River Bend Station - Unit 1  
Docket No. 50-458

GULF STATES UTILITIES COMPANY  
RIVER BEND STATION  
LICENSE NPF-47

AC SOURCES  
(91-04)

In accordance with 10CFR50.90, GSU requests a revision to the River Bend Station (RBS) Unit 1 Technical Specifications, Appendix A to Facility Operating License NPF-47. This change request would increase the required high pressure core spray (HPCS) Diesel Generator (DG) start from 10 to 13 seconds. GSU has determined this change will not affect the previous safety analysis and will increase the reliability of the DG.

FIGURE 1

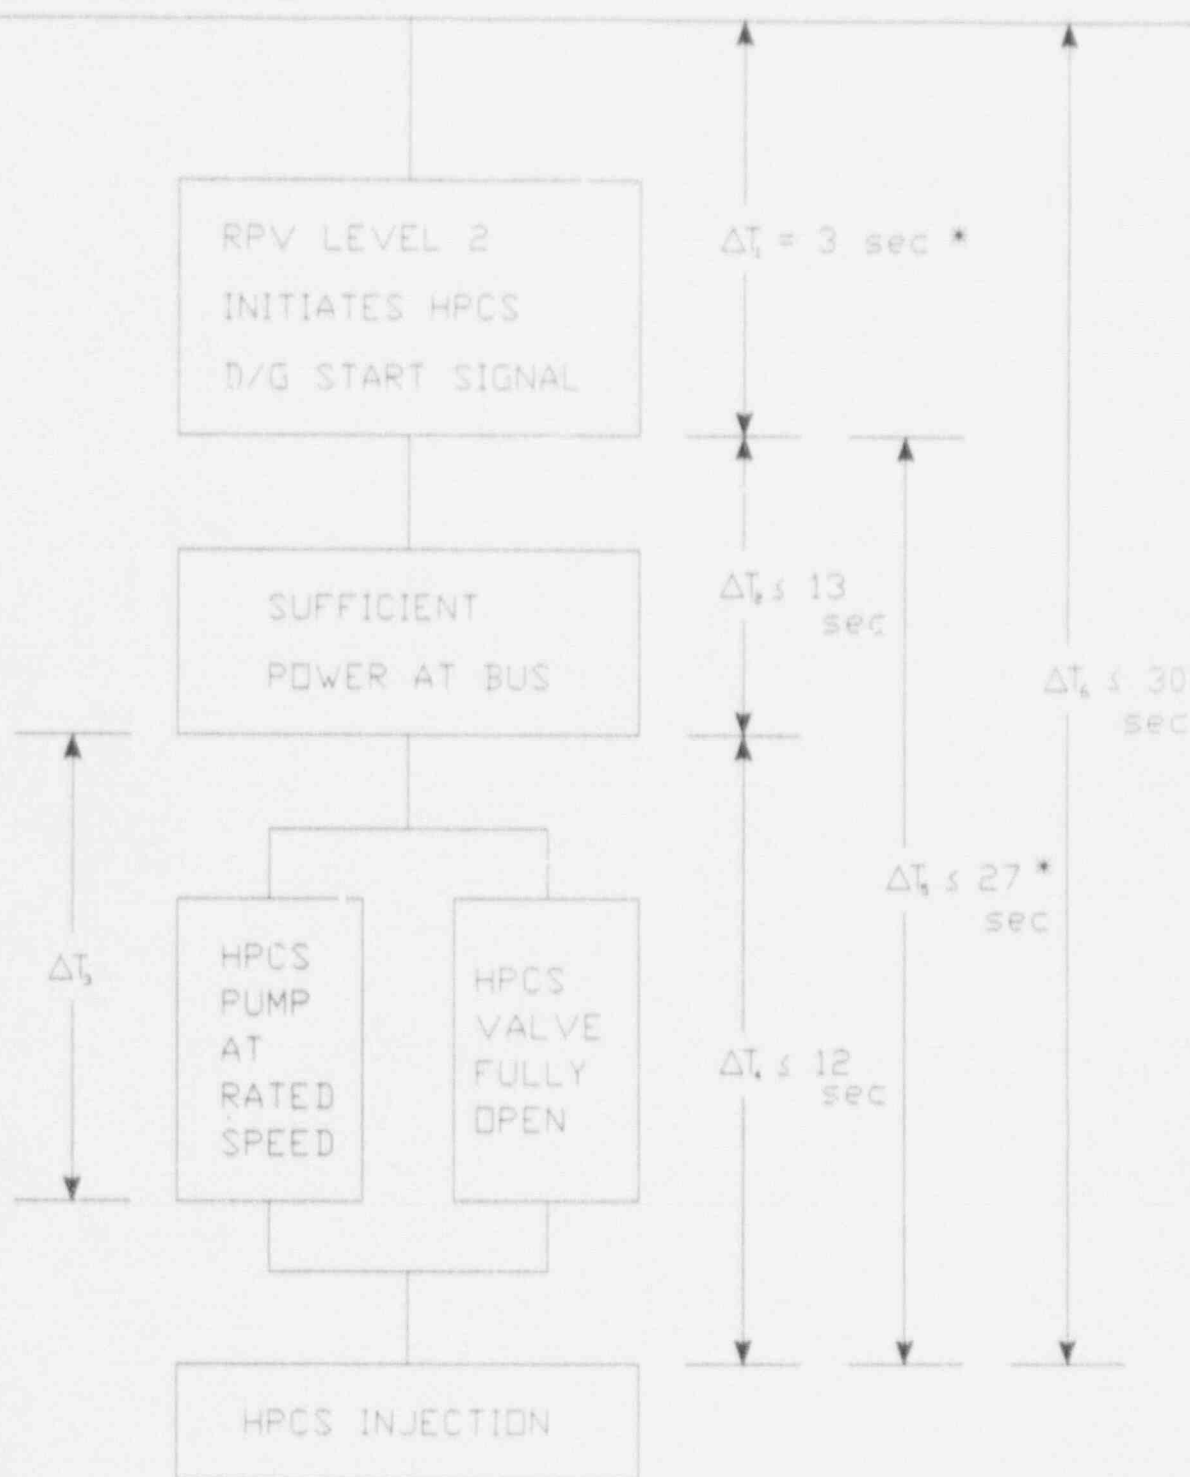
The HPCS system is described in Section 6.3.2.2.1 of the Safety Analysis Report (SAR) with additional design information included in Sections 8.3.1.1.3 'HPCS DG' and 9.5.6.1 'HPCS power supply system'. The design basis of the system affected by this request is contained in Section 15.6.5 'Loss of Coolant Accidents (LOCA)'. The major components of the HPCS system addressed by this change are the DG, pump and the injection valve '1E22\*F004 (F004)'. The analysis contained in the current SAR remains as originally proposed by GSU which was reviewed and accepted by the NRC in Supplement 2 to the Safety Evaluation Report (SER). This analysis requires the HPCS to attain design flow and pressure within 30 seconds after a design basis LOCA concurrent with a loss of offsite power. In the licensing calculations the DG is assumed to be activated by the low water level in the reactor with no credit taken for the high drywell signal. The low water signal (level-2) is reached in about 3 seconds from the occurrence of the line break. With a 10 second DG start time, the electrical supply bus is powered in 13 seconds. In addition to the above, no credit is taken for the make-up water in the calculations until the F004 valve is fully open; therefore, HPCS flow to the reactor vessel does not commence until 30 seconds. The significant items and time periods in the SAR analysis are illustrated in Figure 1 and summarized as follows:

<u>ITEM</u>	<u>TIME</u> (seconds)	<u>TOTAL TIME</u>
LOCA start	0	0
HPCS start signal	3	3
F004 open/pump start	12/13	15
Full injection	--	30

Note: The pump start is in parallel with the valve opening.

The above information illustrates there exists in the present analysis a total of 15 seconds for the HPCS DG to start and reach rated conditions. The present technical specification (TS) requirements contained in specification 4.8.1.1 require the DG reach these conditions within 10 seconds; therefore there exists a 5 second margin within the present analysis without any changes to the response of the plant. This margin is also not required to support any analysis or affect any required function assumed in the SAR including those calculated in accordance with 10CFR50.46 under 10CFR50 Appendix K assumptions. As a result, an increase in the HPCS DG starting time from 10 to 13 seconds will not change the calculated effects to the public and therefore remains within the original licensing basis.
